# DESIGN REPORT

## **Westlink Stage 2, Kemps Creek – Naturalised Trunk Drainage Channel Design**

3 April 2025

Appendix A - Agency Response to Submission For ESR Stage 2 Trunk Drainage Channel

**Figure 6: Sinuosity diagram (Brisbane City Council, 2000)**

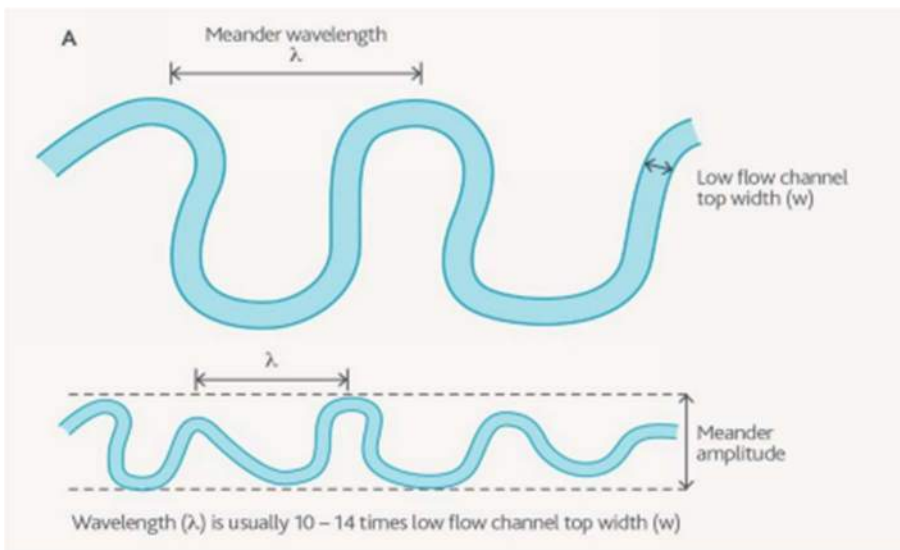
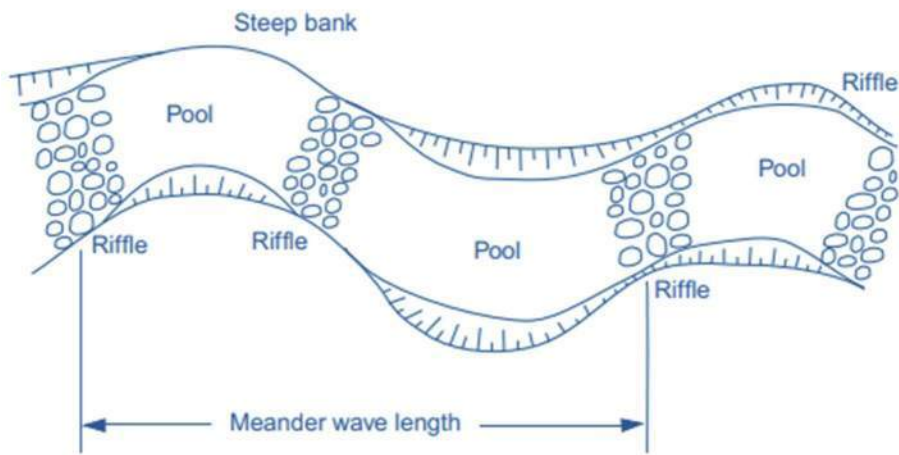
*The current design does not achieve the target for sinuosity.*

- *Sydney Water recommended increasing the average wavelength.*
- *After retaining a minimum 1m buffer, the proponent could potentially transfer the remaining portion of the 2m buffer next to the maintenance track to the upper bank to allow for an appropriate channel wavelength.*

The failing parameter in our current design is the average wavelength. Which we understand the requirement for the average wavelength is to be  $\geq 10 \times$  Low Flow Channel Top Width (ie  $\geq 40$  m).

Based on the Sydney Water sinuosity diagram (Figure 6 below) the average wavelength achieved in our current design is 15m.

However, we believe the full cycle of the sine curve meander should actually be adopted as the wavelength i.e **DOUBLED** (see other diagram from Brisbane City Council and Melbourne Water below).

Also with this in mind, would Sydney Water accept being slightly under this criteria given we comply with all the other criteria?

LOW FLOW CALCULATIONS

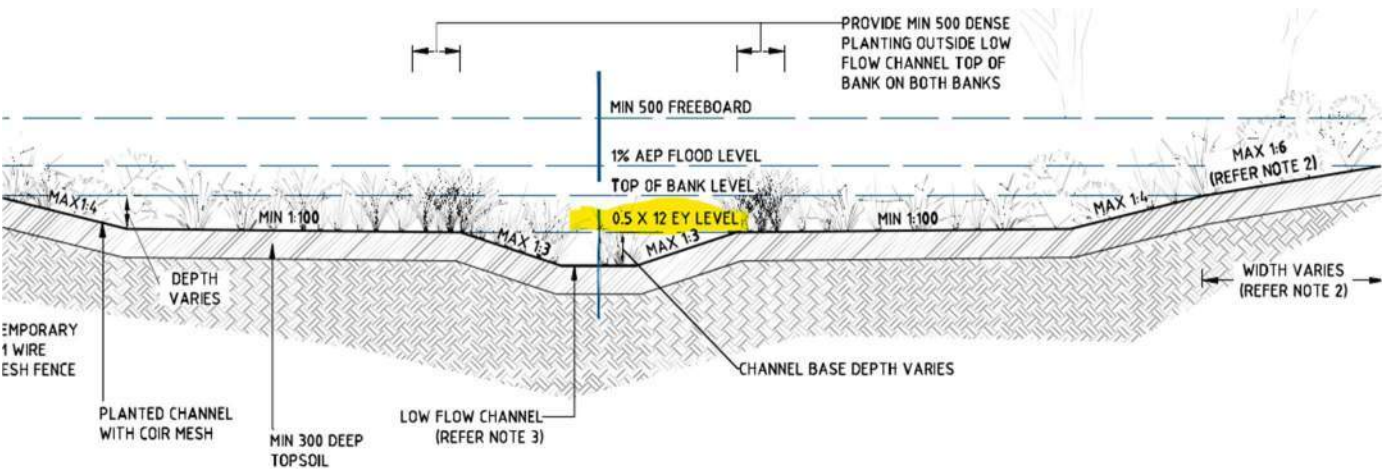
Sydney Water Comment

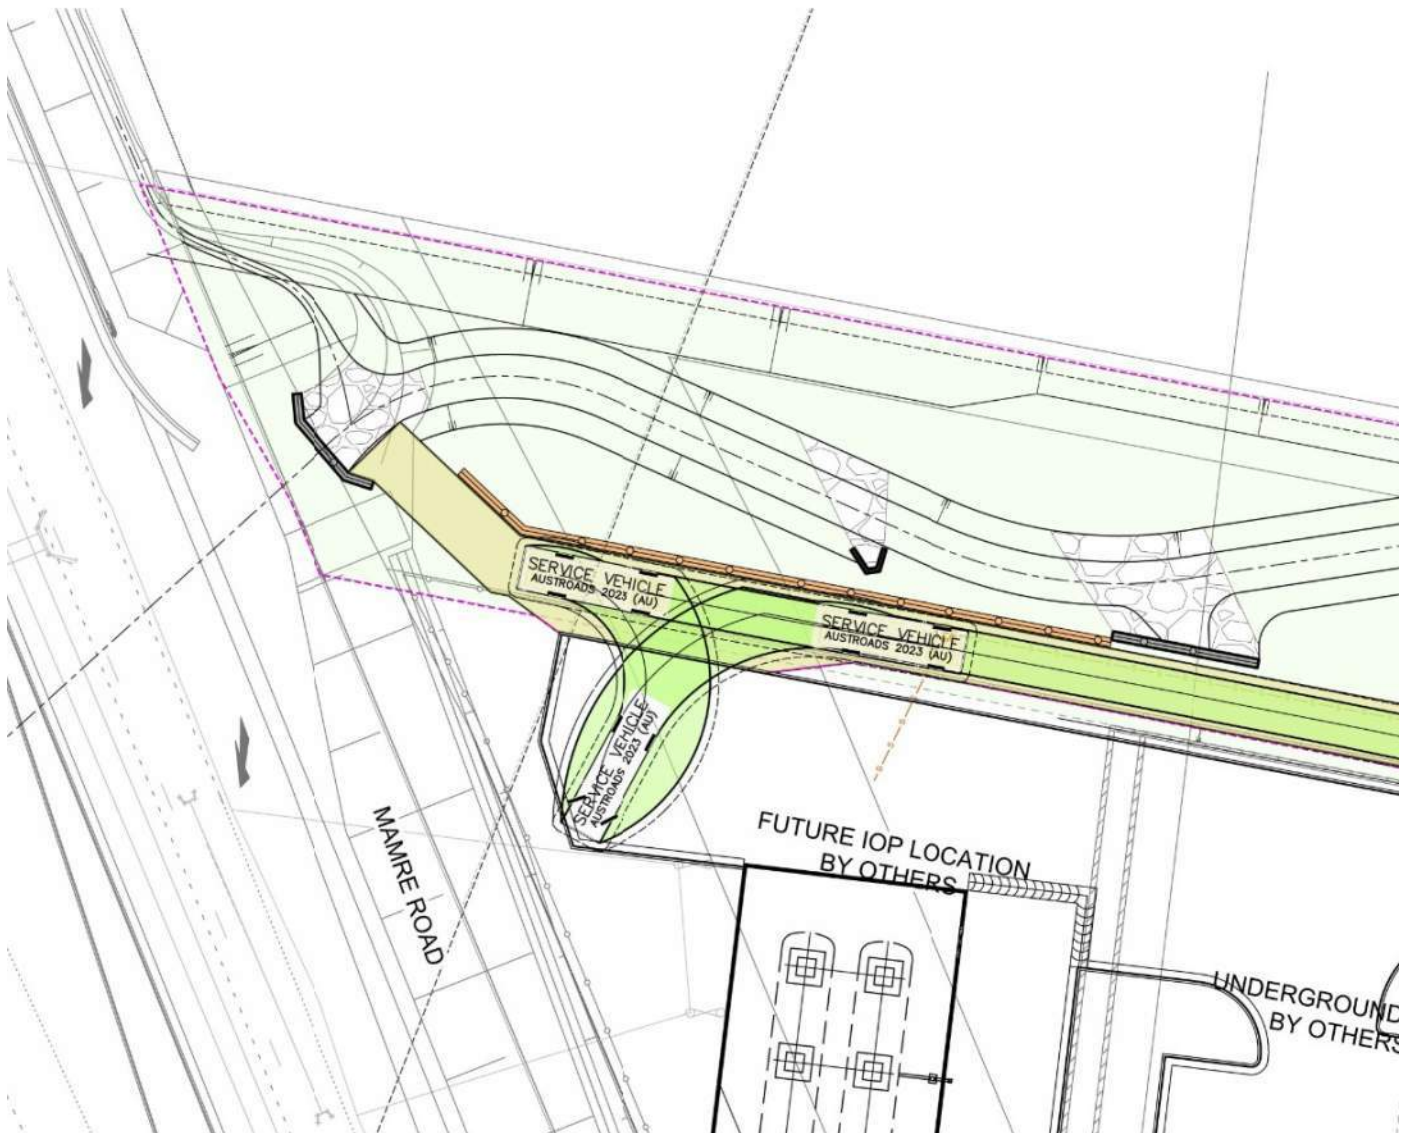
You may recall that one of the items was about the positioning of the maintenance track and whether SWC have any requirements to have maintenance access to the headwall under Mamre Road. (i.e to clear debris / blockages, etc).

After consideration of a few options (including access from above via Mamre Road), we've landed on the below. This option allows for a service vehicle to turn around within the sealed area in front of the IOP. With provision being made for a section of ramp to provide access down to the headwall.

**Figure 5-1**  
**Westlink Stage 2**  
**Naturalised Trunk Drainage**  
**Channel**  
1% AEP  
Developed Conditions NoTW  
Flood Depths and Levels

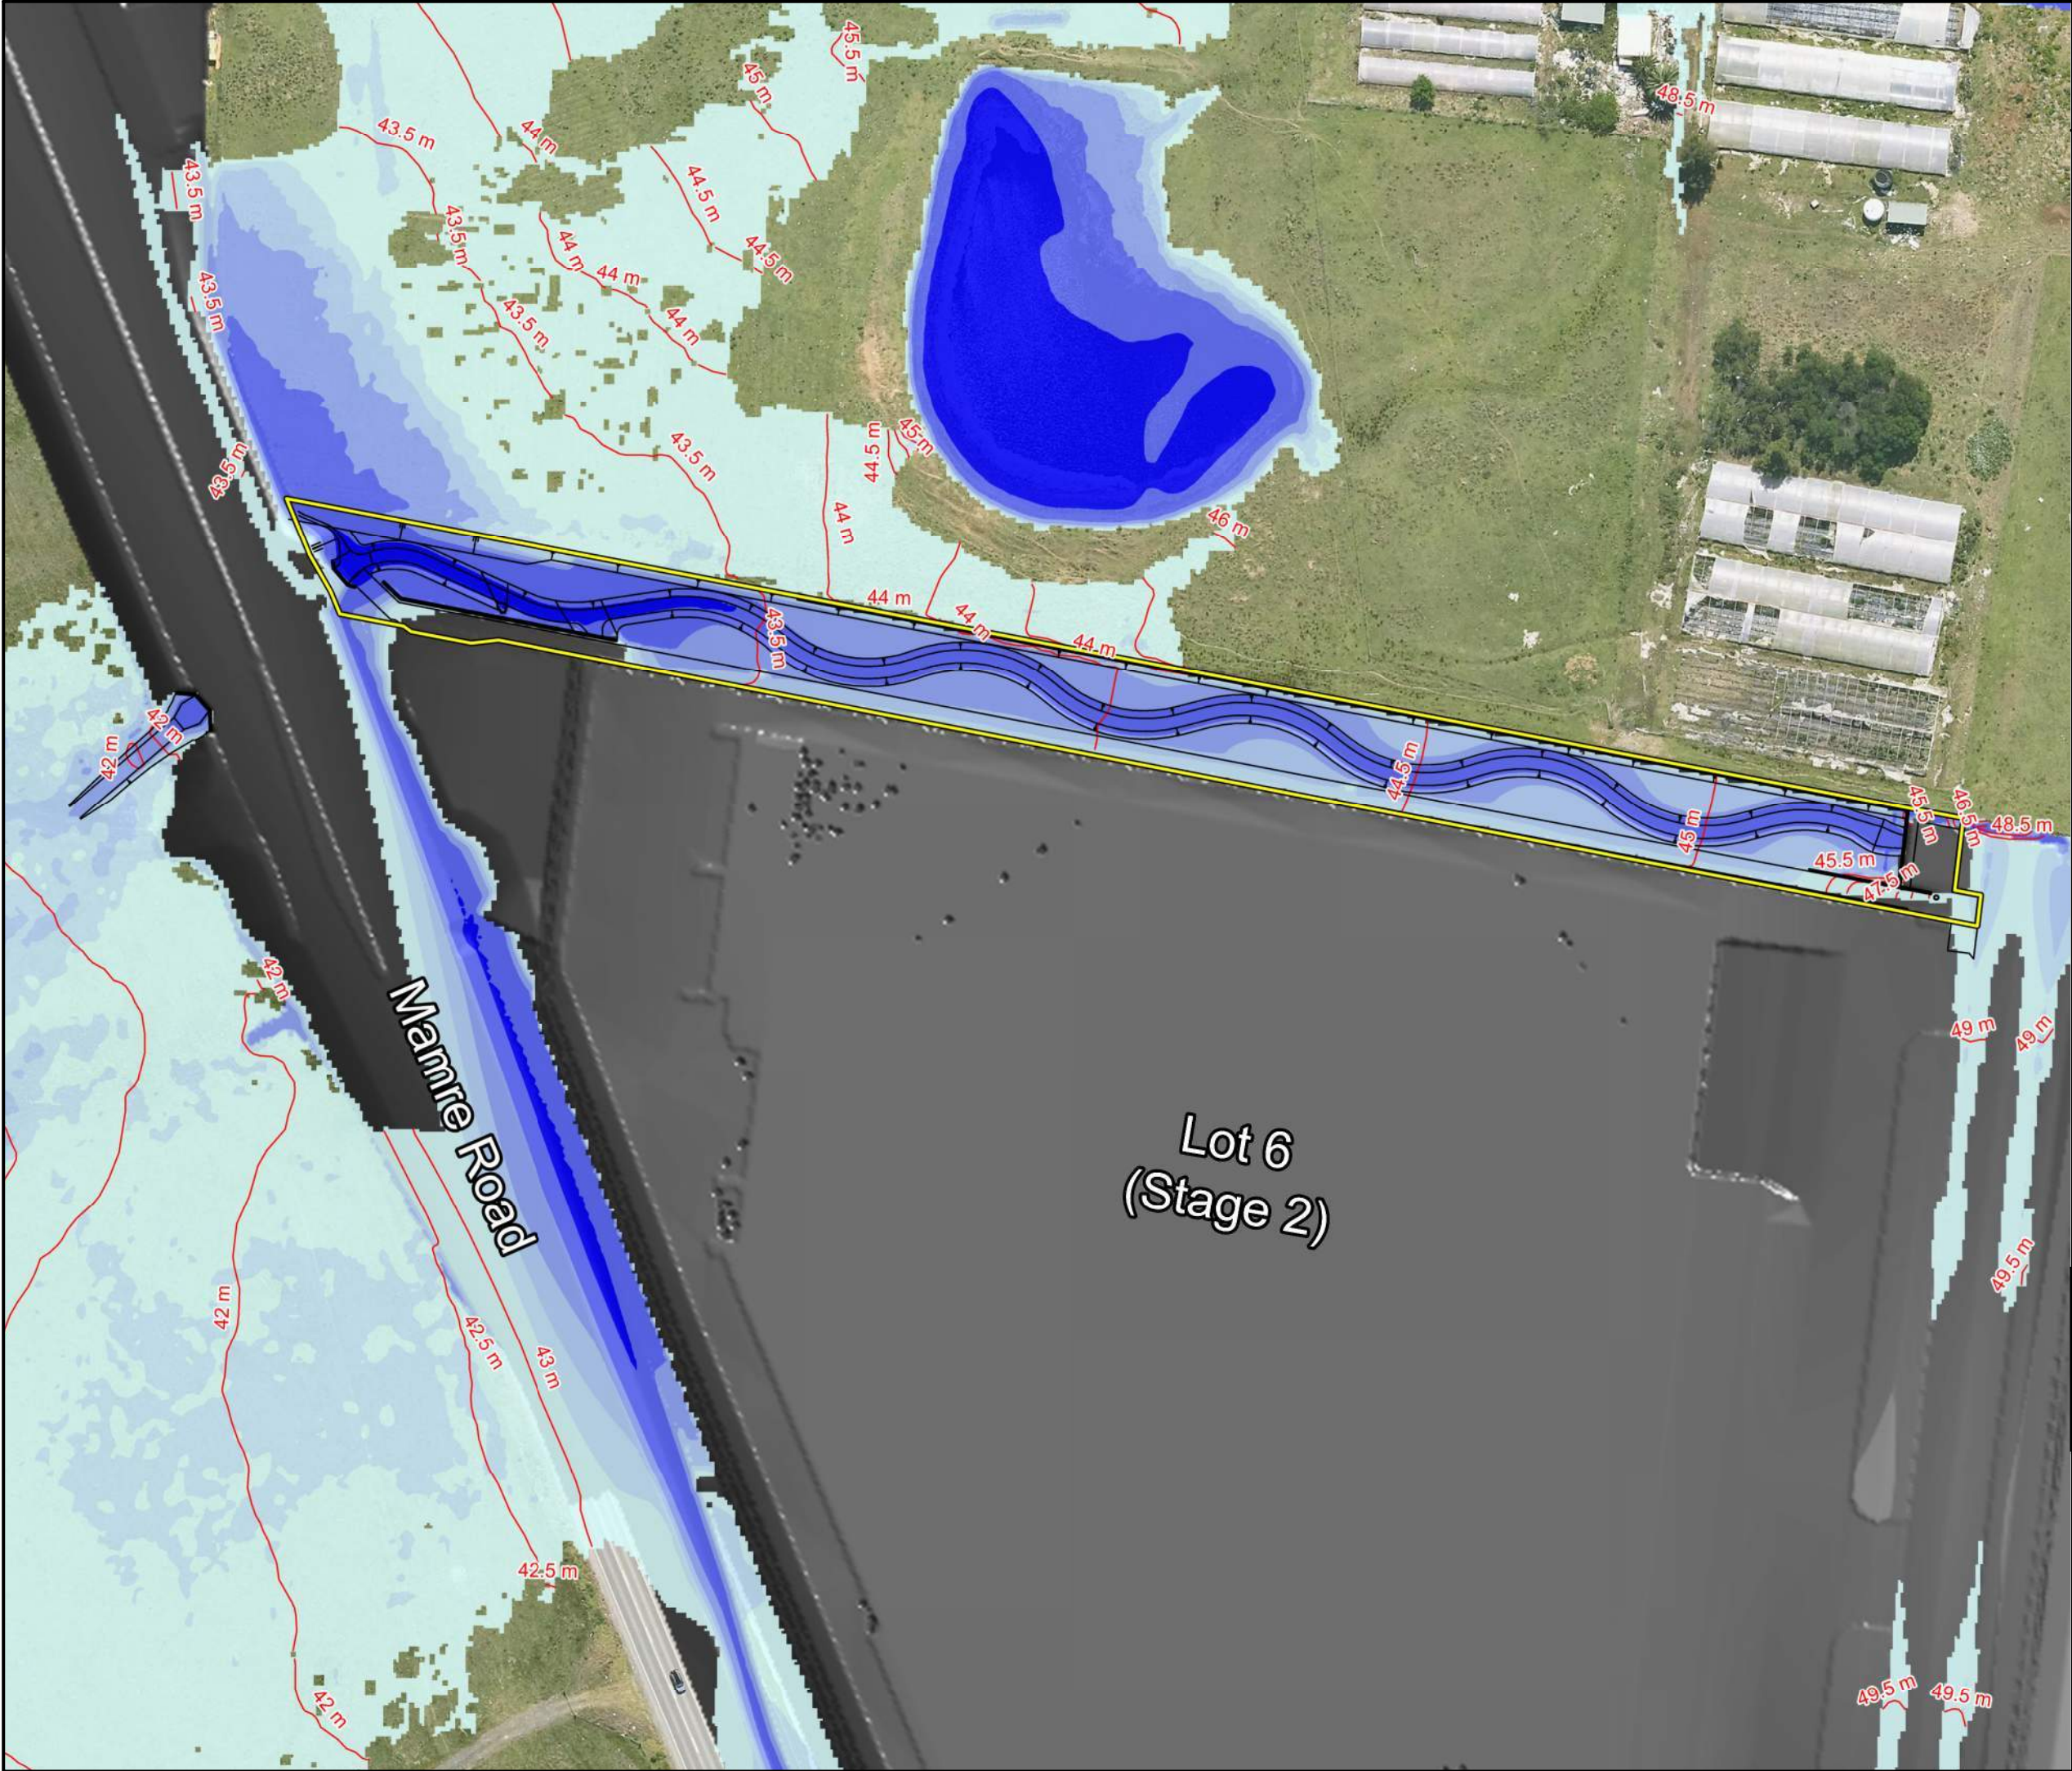
Water Levels of Minor Storm Event, 1% AEP And 0.5m Freeboard	To be provided	Open	Figure 5-1 in Appendix F demonstrates the water levels across the channel in the 1% AEP, with flows being contained in the channel with freeboard. The 1% AEP flood levels have also been included on each of the channel sections provided on sheets DD020-DD021 of the JWP Engineering Drawings	
Private Retaining Walls and Easement shown on Plan	To be provided	Open	A Sydney Water Easement Plan is also included on DD007 showing the 19.2m drainage easement width (including the overall area of the system) along with the 0.8m residual plan. Also refer to the Plan of Subdivision by Land Partners (Ref: SY074698.000.01) for Setout Details. Details and long sections of the proposed retaining walls are included on drawings DD030 to DD036.	
<b>Long Section Drawings</b>				
Inverts Levels and Slopes	To be provided	Open	Long sections for the proposed channel is shown on JWP Engineering Drawing DD016. This includes the connection to the downstream culvert under Mamre Road (by others)
